**ADDENDUM No. 6**  
**STREET DEPARTMENT GARAGE FACILITY - 2024**

**City of Oregon**  
**Department of Public Service**

C6

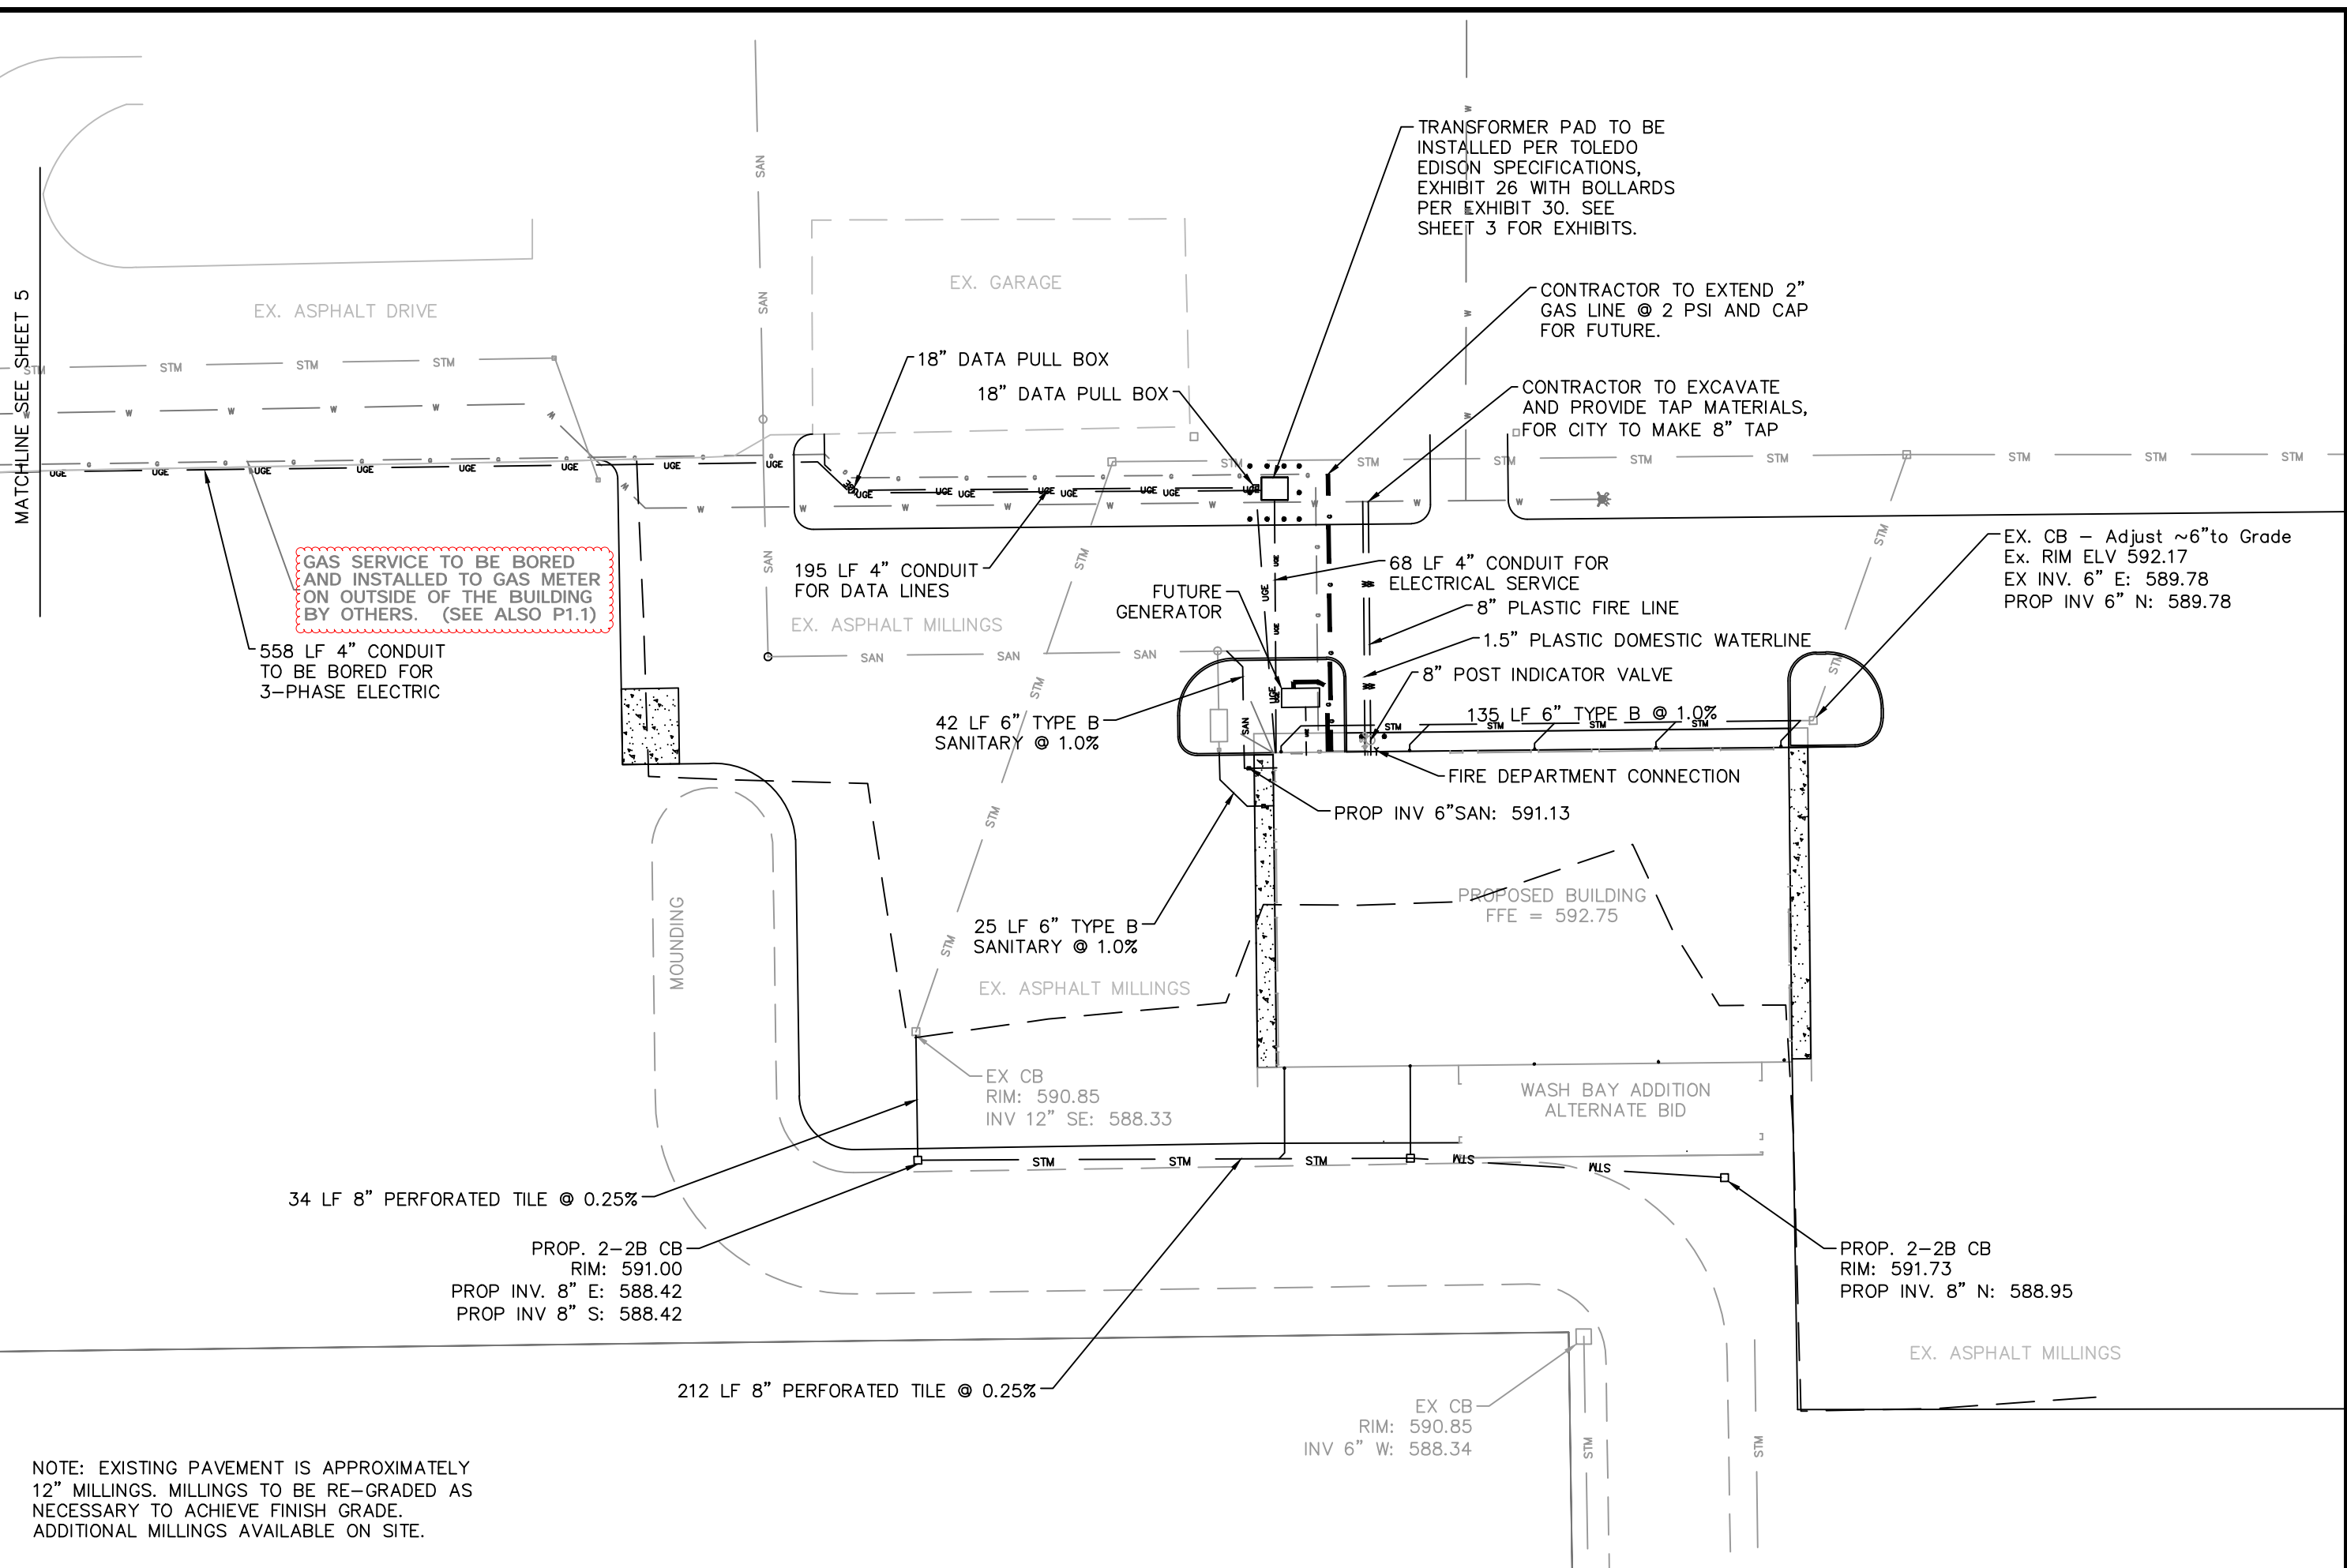
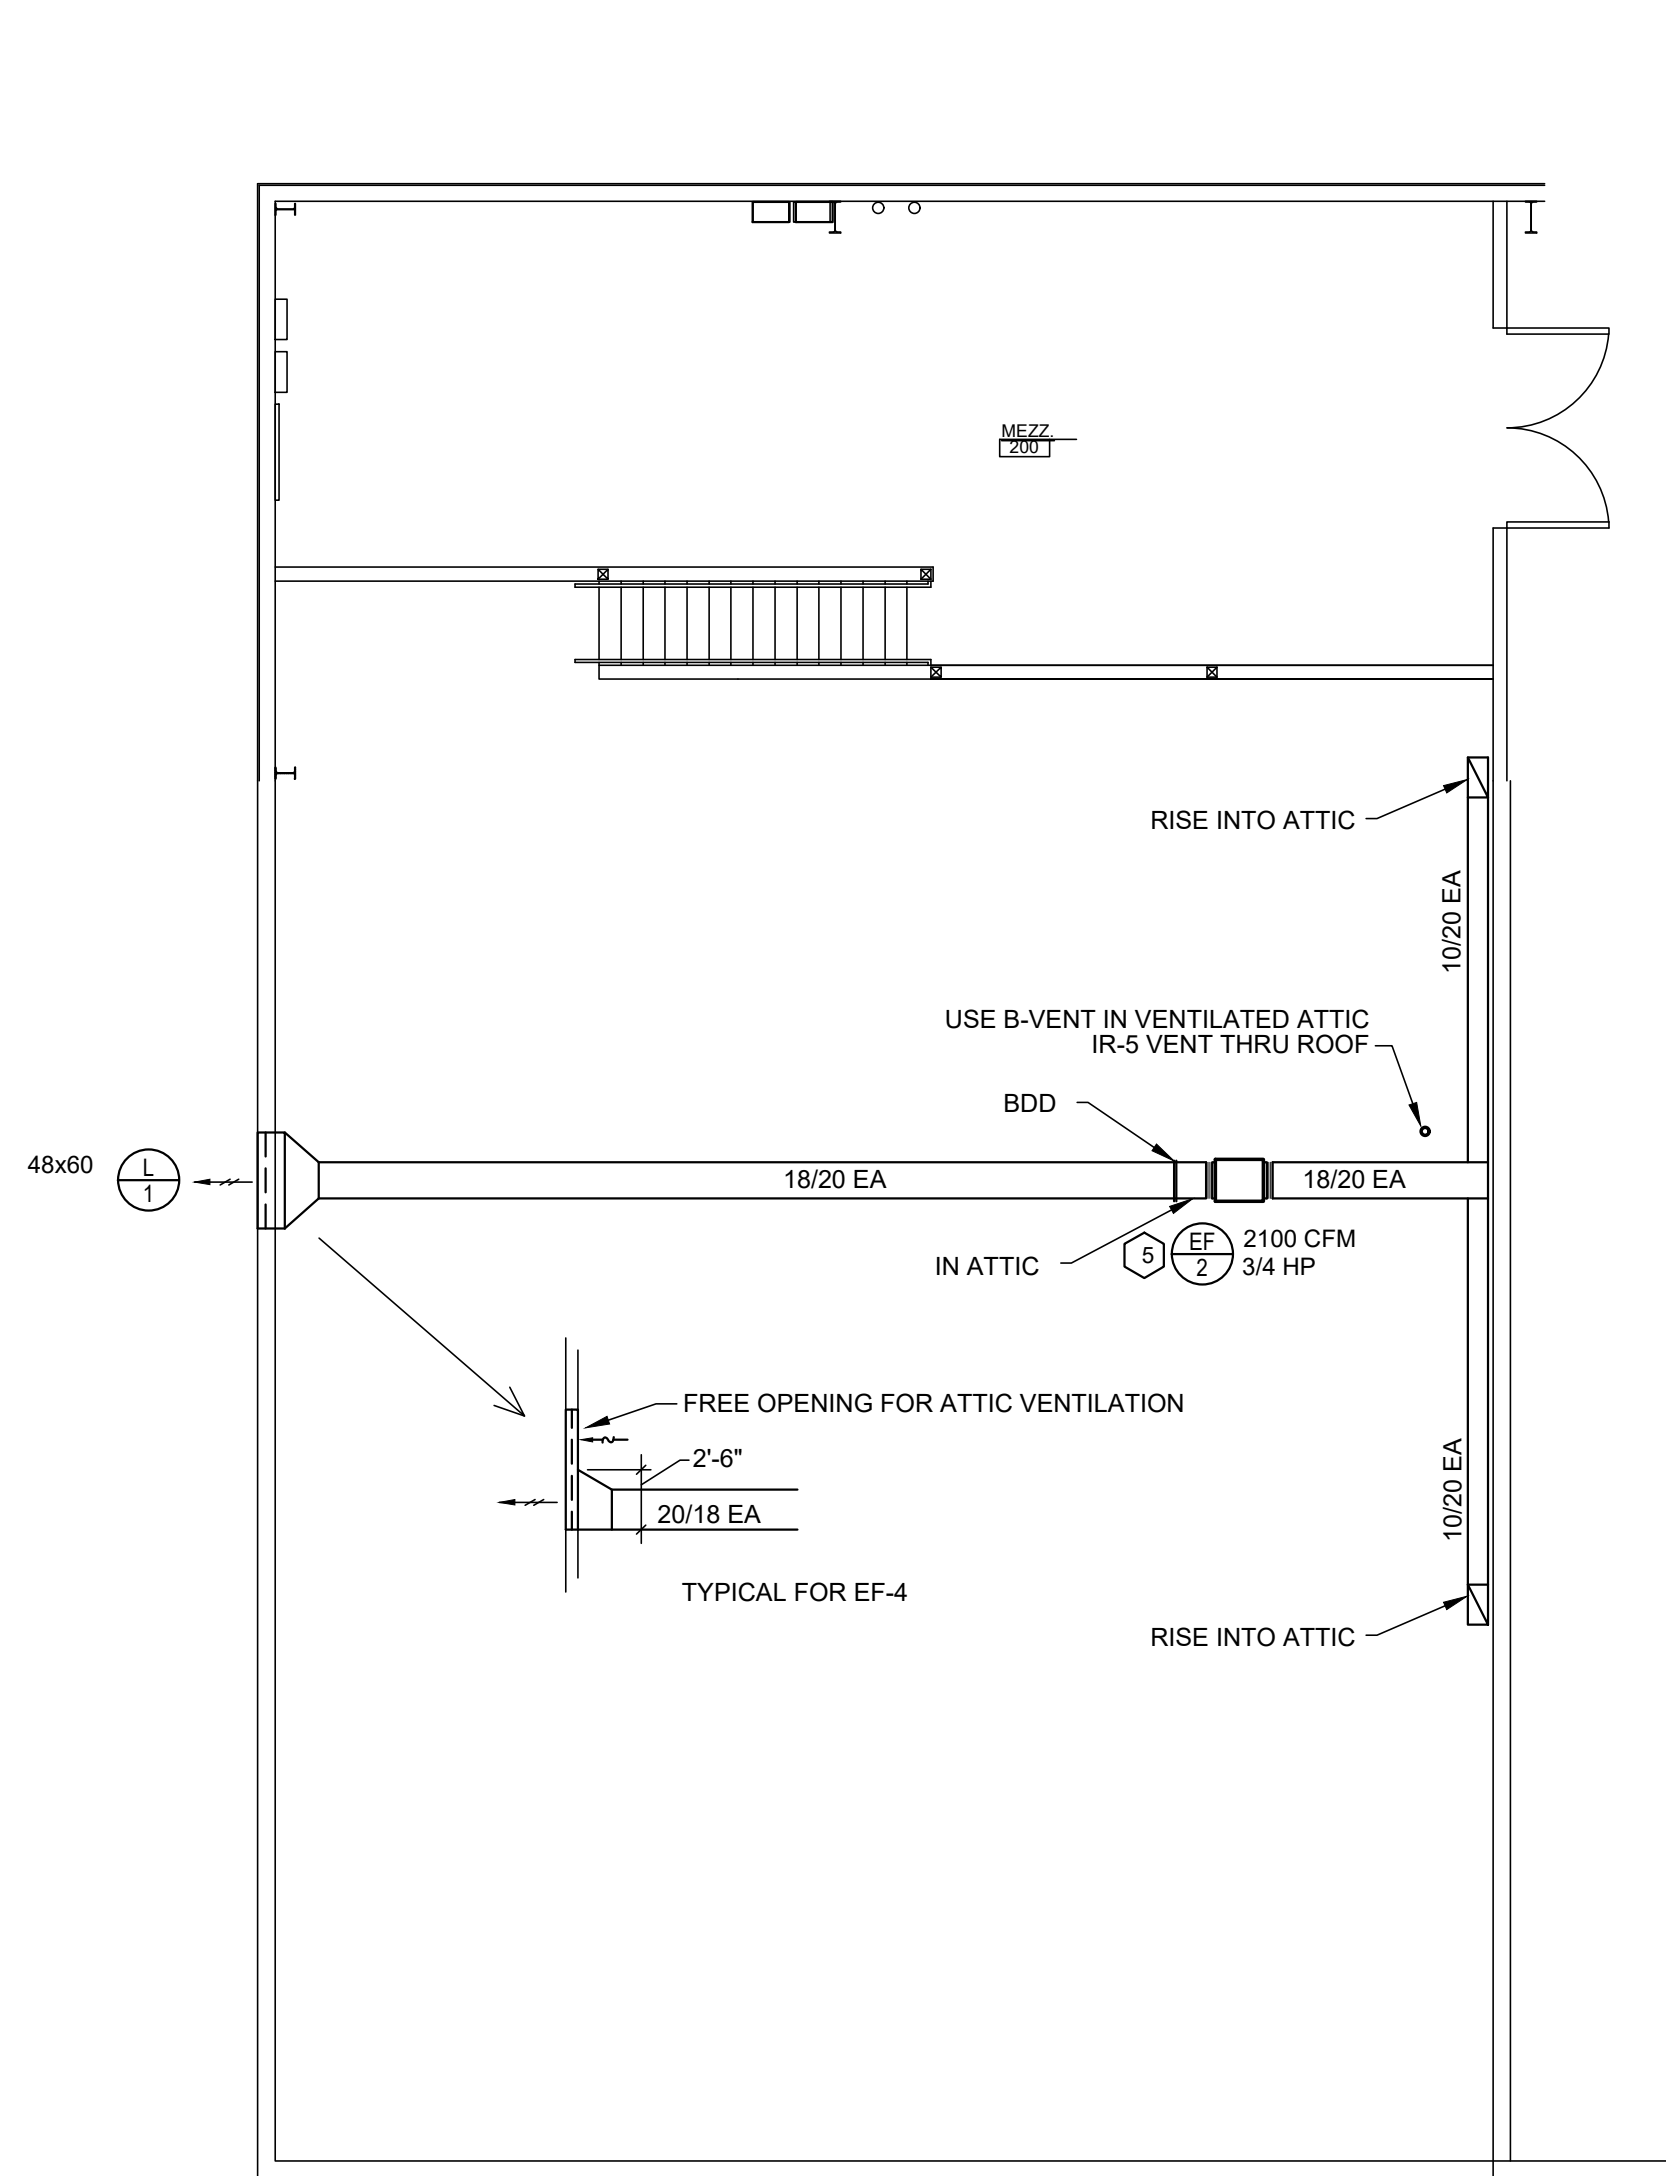
- See attached revised drawing C6 for additional clarification for gas line.

4) **Bidder Question:** *Regarding the new underground gas line. A portion of this line is called out as being bored in by others. Another note at the elbow where the line turns and heads west towards the building, calls out that the contractor is extending the line and capping for future. Is the Owner responsible for the gas line that feeds the building and contractor is only responsible for a separate line that is capped for future use? Is the future line for the generator, and thus would be turned up within the curb near the future generator?*

**Architect/Engineer Response:** Columbia Gas to install underground service line and meter setting. Contractor is responsible for gas piping after the meter. See revised plumbing drawing P1.1 and C6.

GAS SERVICE TO BE BORED AND INSTALLED TO GAS METER ON OUTSIDE OF THE BUILDING BY OTHERS. (SEE ALSO P1.1)

CONTRACTOR TO EXTEND 2" GAS LINE @ 2 PSI AND CAP FOR FUTURE.
